Illinois Department of Transportation

SUBJECT: Quincy Regional Airport
Quincy, Illinois
Adams County
Illinois Project Number: UIN-5051
AIP Project Number: 3-17-0085-TBD
Contract No. QI066
Item No. 06A, April 28, 2023 Letting
Addendum A

NOTICE TO PROSPECTIVE BIDDERS

RECONSTRUCT RUNWAY 4/22
PHASE 4

1 RUNWAY SAFETY AREA DELINEATOR ⚠

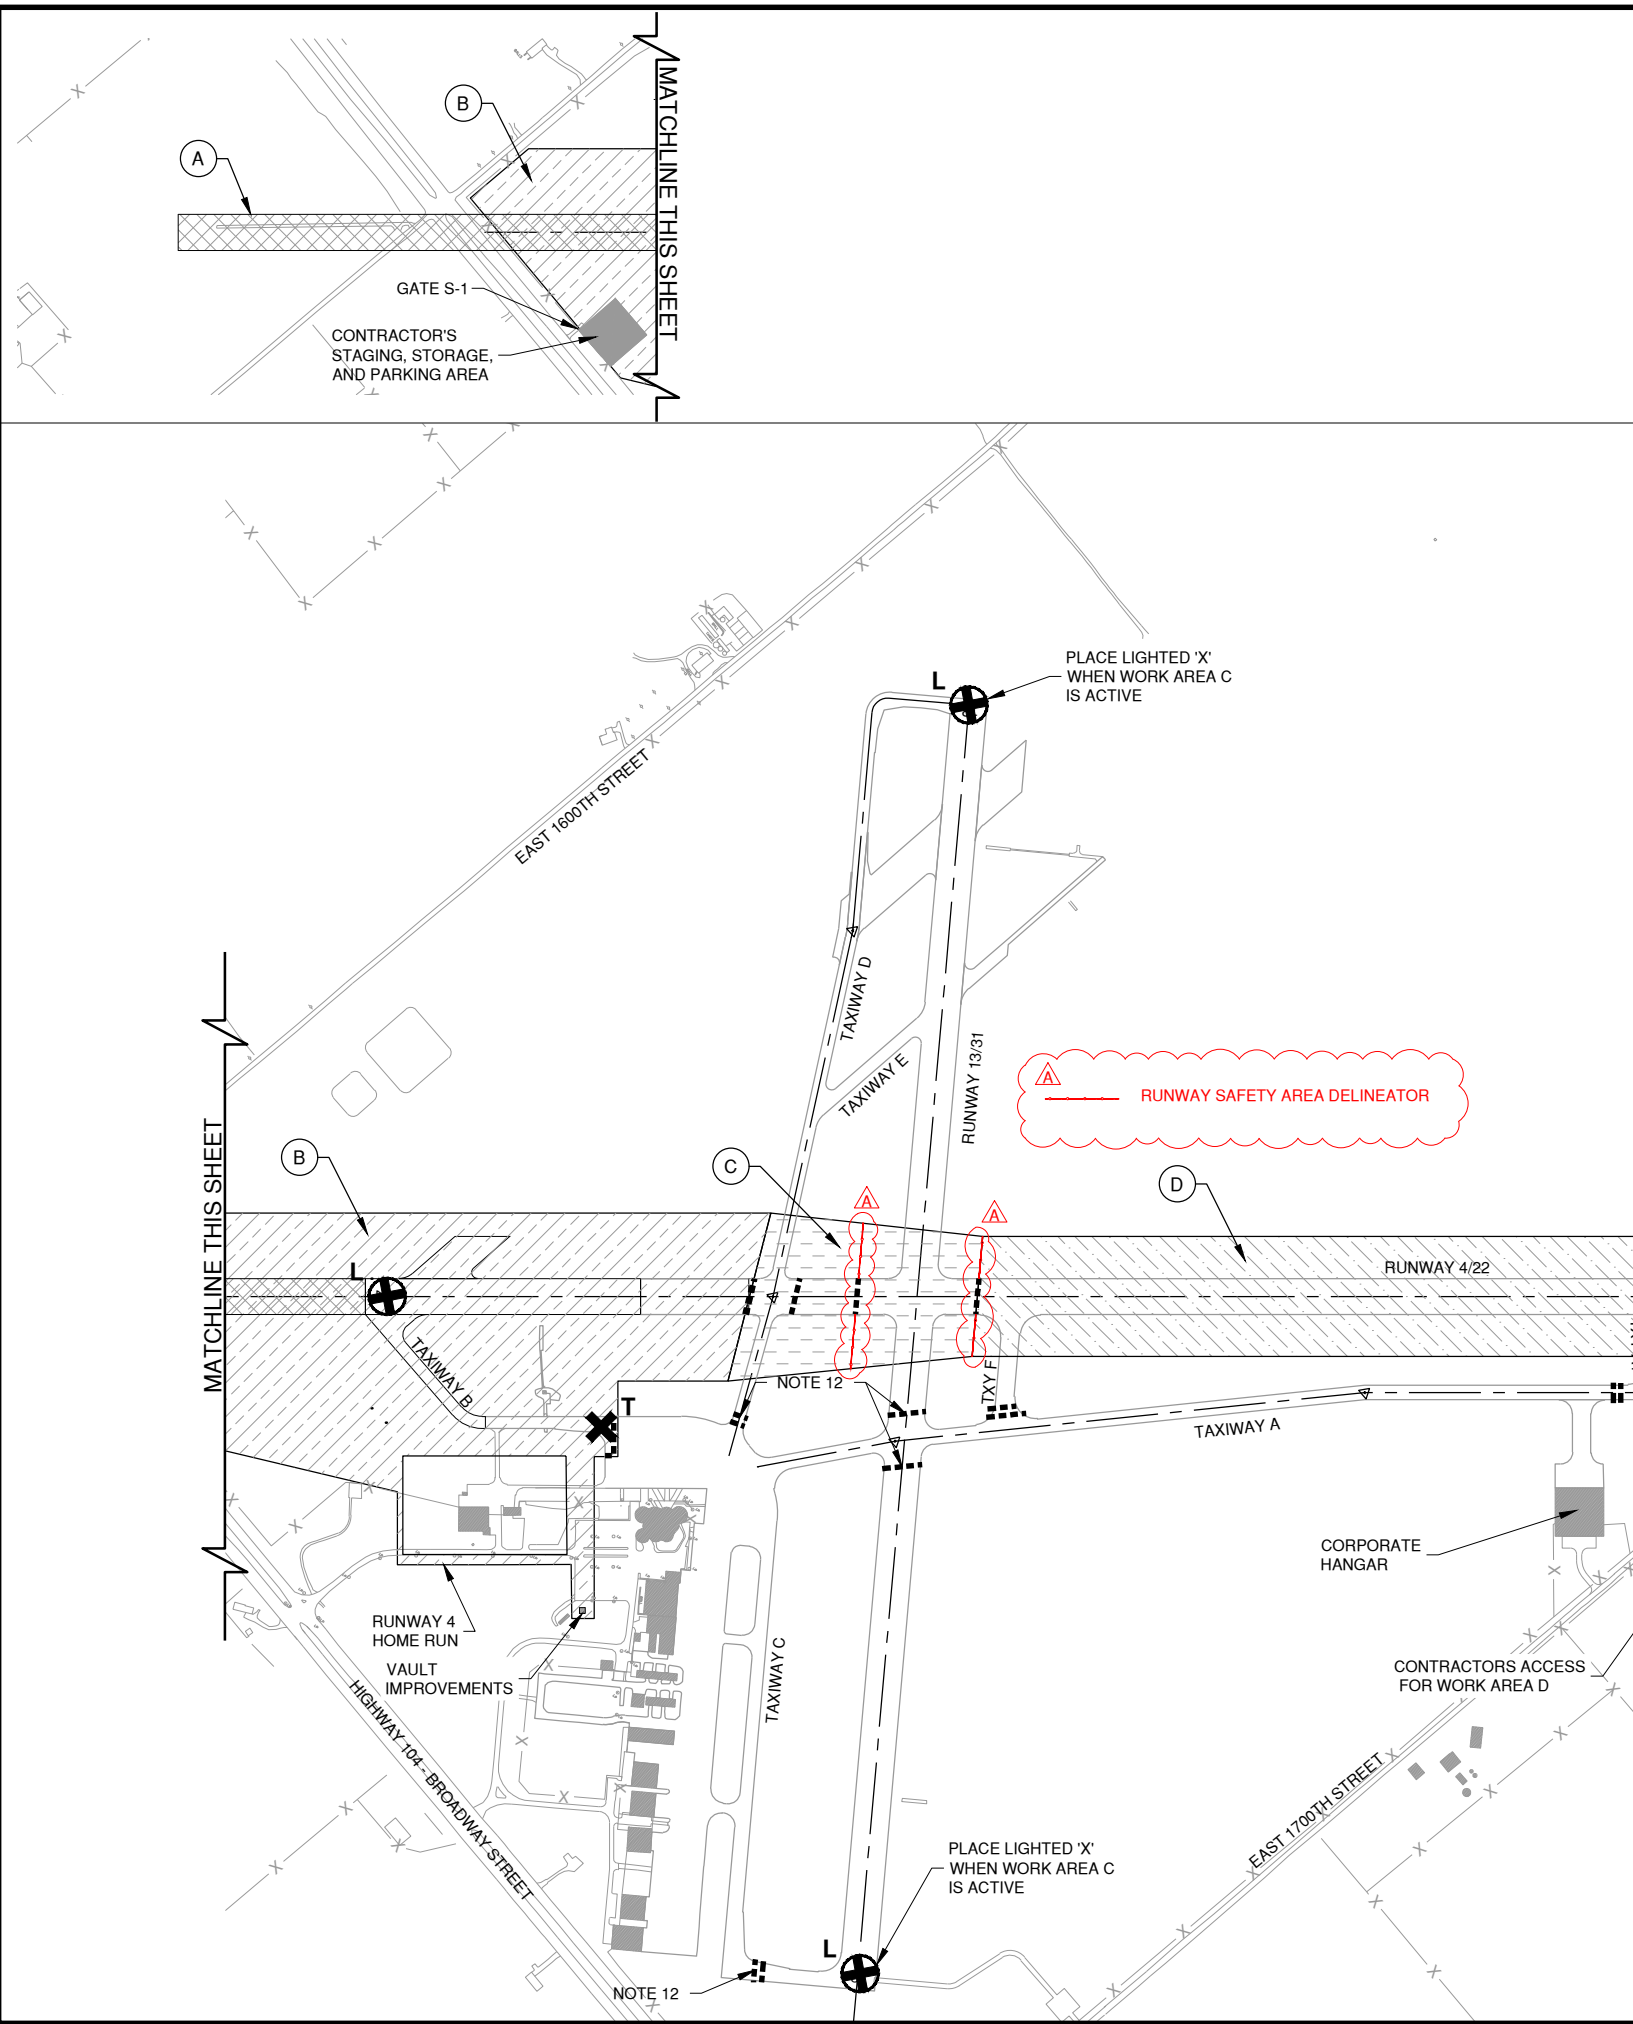
- Sheet GI003
 - ADD: Pay Item AX110504, 4-Way Concrete Encased Duct
 - REVISE: Units of Measure to agree with Schedule of Prices
 - ADD: Recorded Quantities column
- Sheet GC004
 - REVISE: Note 2 to read "PLACE ALONG THE RUNWAY 13/31 SAFETY AREA AS SHOWN ON SHEET GC101."
- Sheet GC101
 - ADD: Location of Runway Safety Area Delineator
- Sheet CG102
 - ADD: The following note:
The Contractor may bury rubblized materials below existing grade between stations 119+50 and 121+50 prior to constructing the embankment.

1. NO SEPARATE PAYMENT WILL BE MADE FOR THIS ITEM. COSTS SHALL BE CONSIDERED INCIDENTAL TO THE PROJECT.
- ~~2. PLACE ALONG RUNWAY 11/20 SAFETY AREA (RSA) AS SHOWN ON THE CONSTRUCTION ACTIVITY PLANS.~~
3. PLACE AND MAINTAIN UNTIL REMOVAL ACCORDING TO CSPP.
4. BARRELS SHALL BE WEIGHTED SUFFICIENTLY TO PREVENT DISPLACEMENT.

2. PLACE ALONG THE RUNWAY 13/31 SAFETY AREA AS SHOWN ON SHEET GC101.

CG102
SHEET 28 OF 143

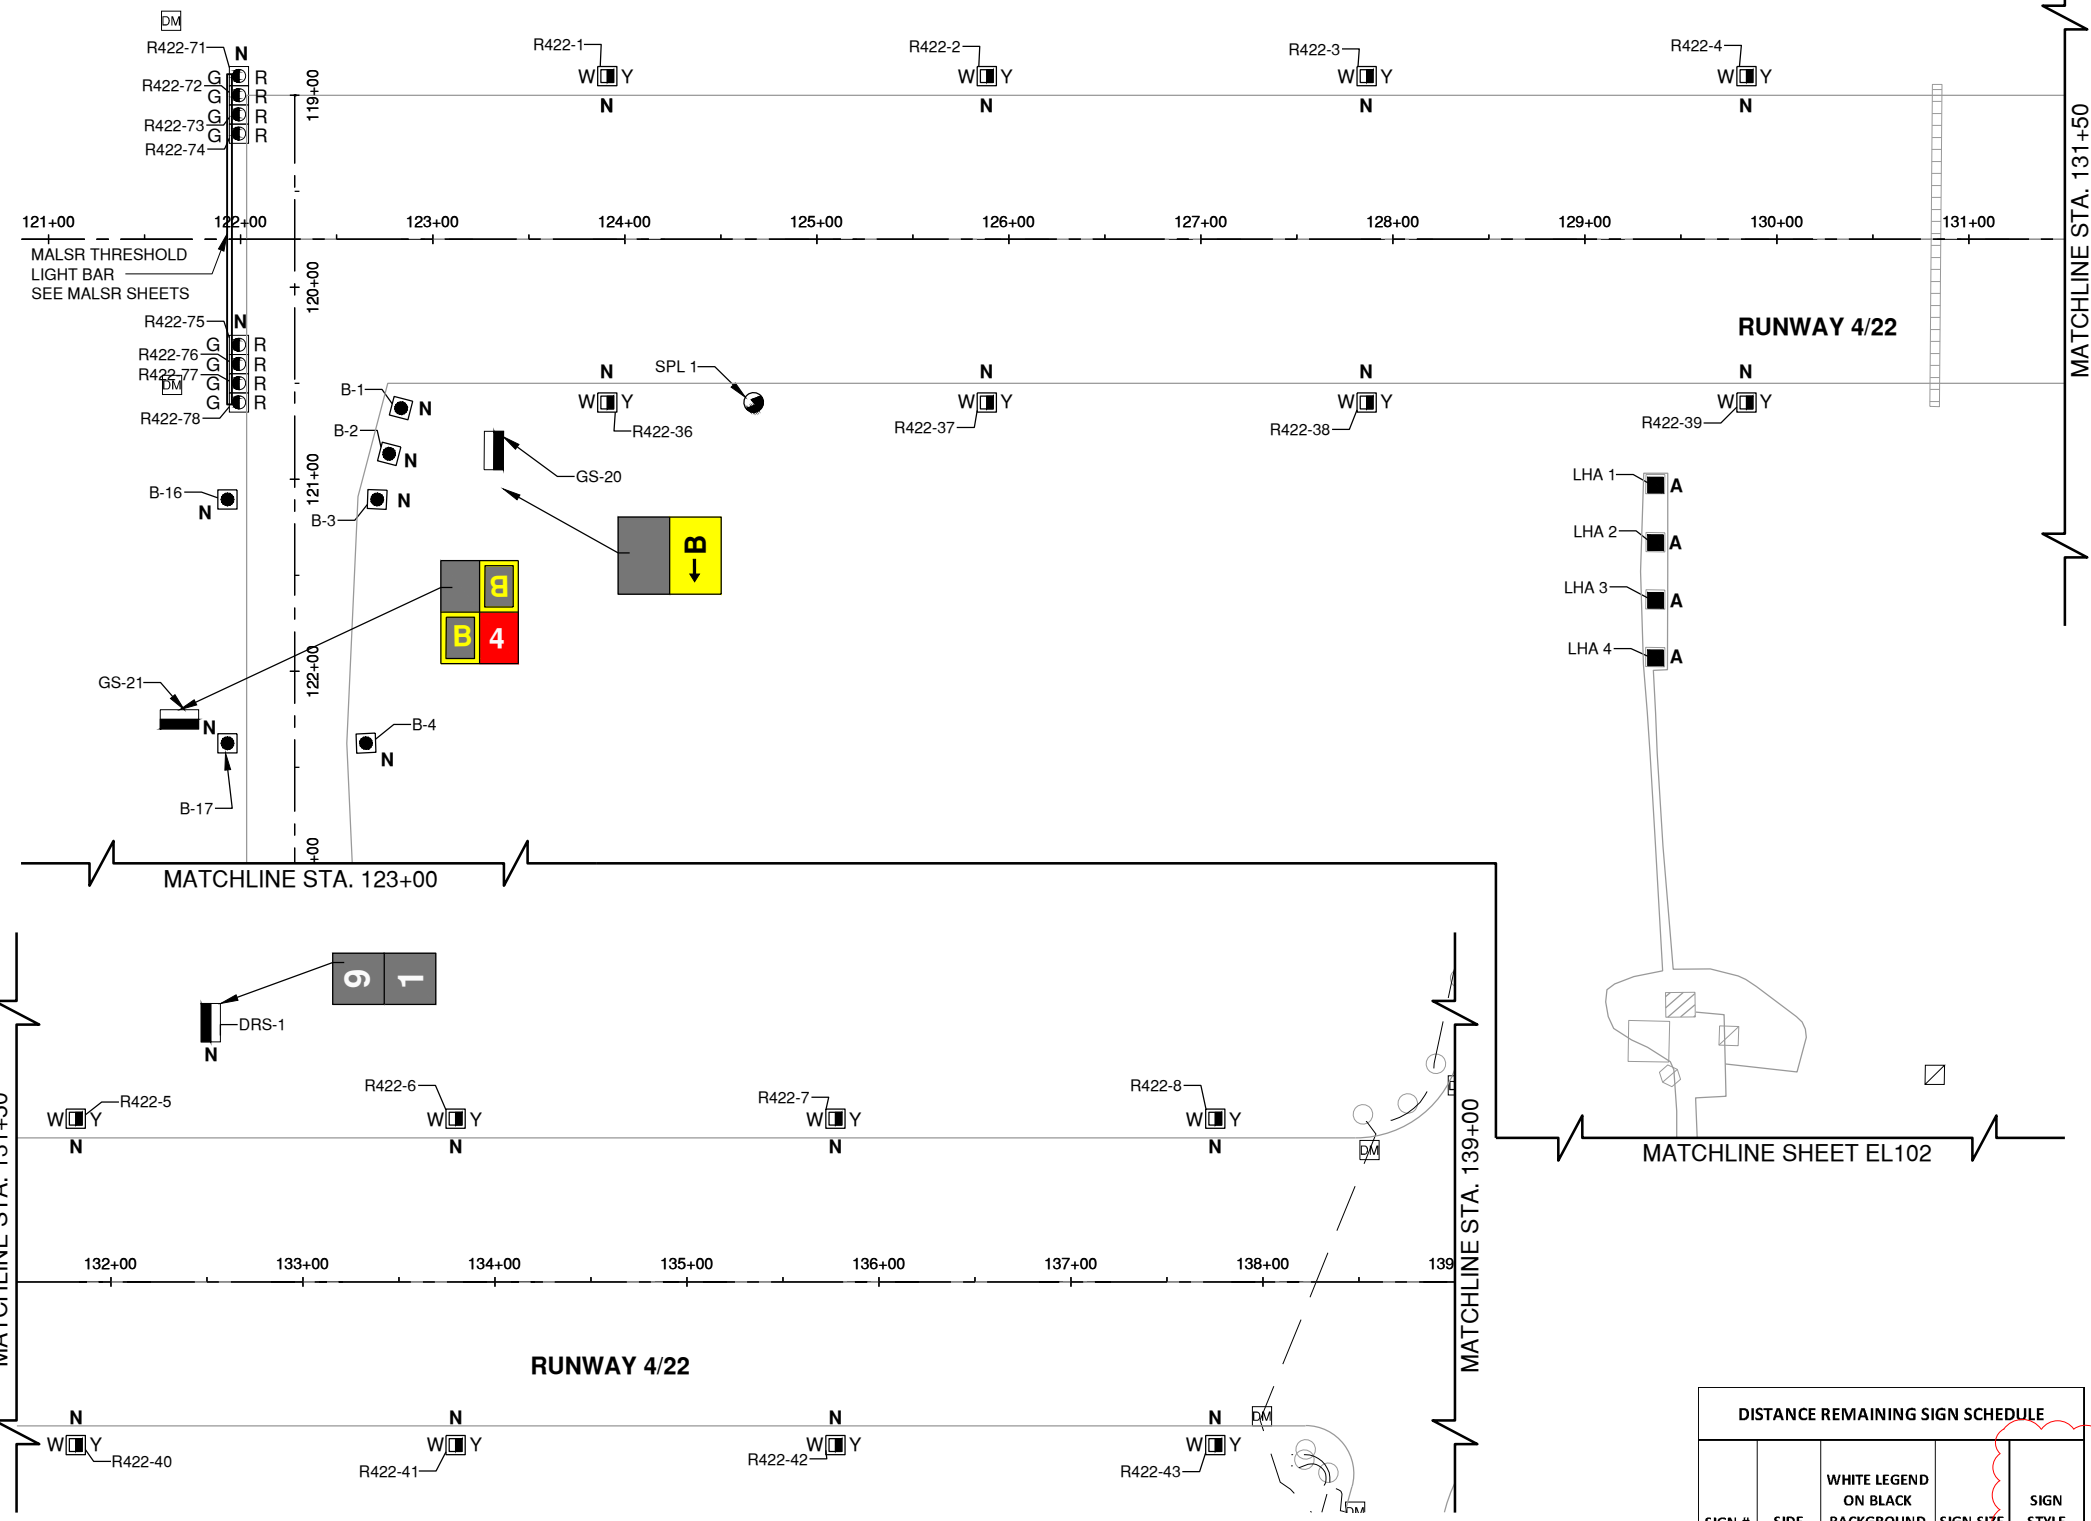
- NOTES**
- RUNWAY SAFETY AREAS SHALL ADHERE TO A TRANSVERSE GRADE OF 1.5% MINIMUM AND 3.0% MAXIMUM
 - MAINTAIN A 5.0% GRADE FOR 10 FEET OF UNPAVED SURFACE ADJACENT TO THE PAVED SURFACE
 - TAXIWAY SAFETY AREAS SHALL ADHERE TO A TRANSVERSE GRADE OF 1.5% MINIMUM AND 3.0% MAXIMUM
 - GRADING OUTSIDE OF SAFETY AREA 1.0% MINIMUM AND 16.67% MAXIMUM.
5. THE CONTRACTOR MAY BURY RUBBLIZED MATERIALS BETWEEN STATIONS 119+50 AND 121+50 PRIOR TO CONSTRUCTING THE EMBANKMENT.

EL109
SHEET 57 OF 143

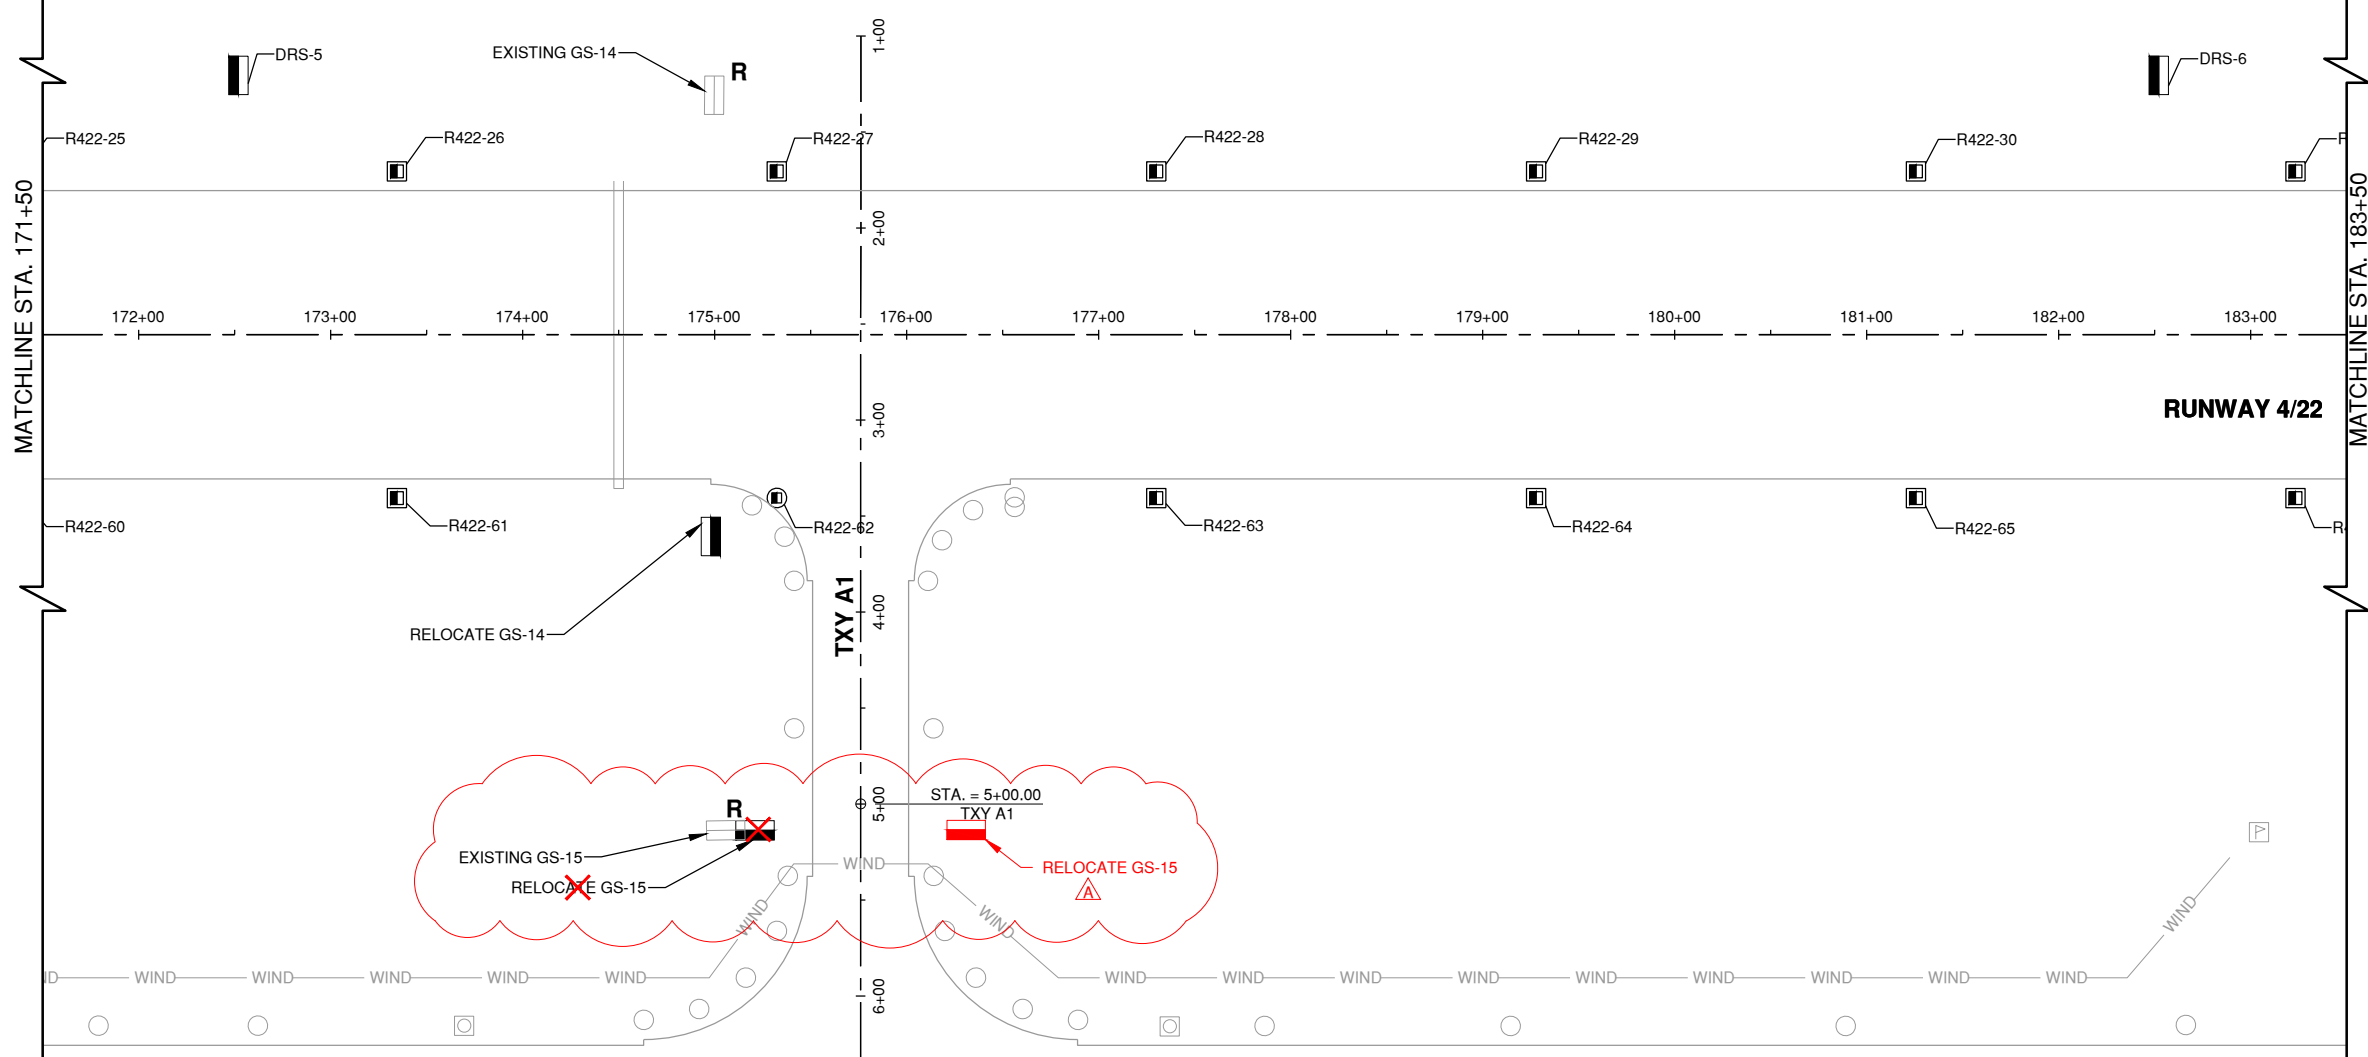
- Sheet EL101
 - Add style column to the Distance Remaining Sign Schedule
- Sheet EL109
 - Move Taxi Guidance Sign GS-15 to the opposite side of Taxiway A1.
- Sheet EL601
 - Revise the offset for sign GS-15.
